MASTER REVIEW REPORT

CASE NUMBER: C814-2018-0121
CASE MANAGER: HEATHER CHAFFIN PHONE #: 512-974-2122

PROJECT NAME: 218 S. LAMAR

LOCATION: 218 SOUTH LAMAR BOULEVARD

4-Lane Divided, 60' Curb-to-Curb
Back-of-Curb Condition F
Barton Springs Road to Riverside Drive

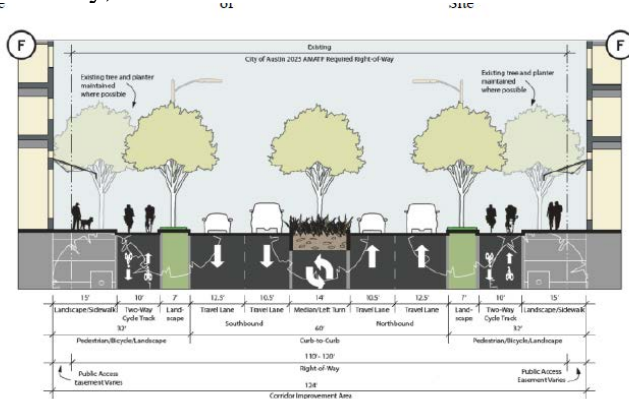
TR2. Include the below streetscape in the land use plan. Contact this reviewer for a more legible copy of it if necessary. This project is adjacent to a street that has been identified in Austin’s Corridor Mobility Program (S Lamar). The sidewalk and bicycle facilities shall comply with the required cross-section at the time of the site plan application. The cross section that will be required is shown below. Find additional information about the Corridor Mobility Program here: <https://data.austintexas.gov/stories/s/Corridor-Mobility-Program/gukj-e8fh/>. Any proposed curb relocations on S Lamar requires coordination with the Corridor Planning Office and Bicycle Program. The cross section will include a 7’ planting zone with street trees, a 10’ two-way cycle track, and a 15’ clear zone all behind curb. Additionally, a protected intersection will be required at Toomey, to be reviewed at the time of Site Plan.

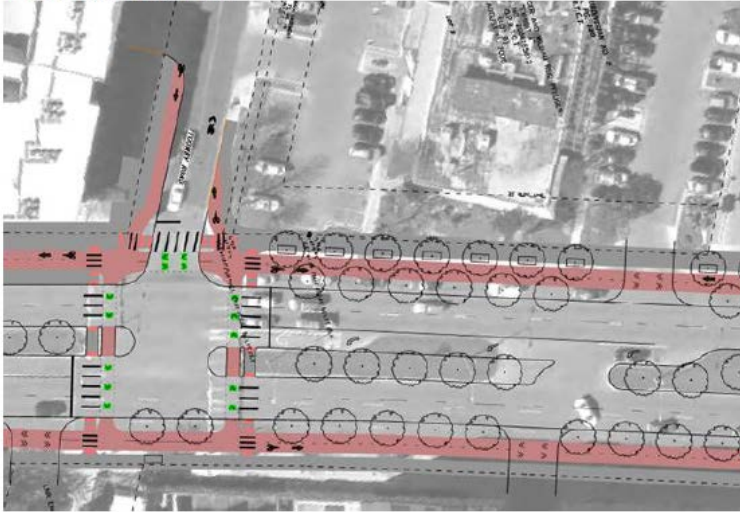
TR5. Bicycle facilities will be required along Toomey Road at the site plan stage. The design is below. Include the below graphic on the land use plan. If a more readable copy is required, contact this reviewer.
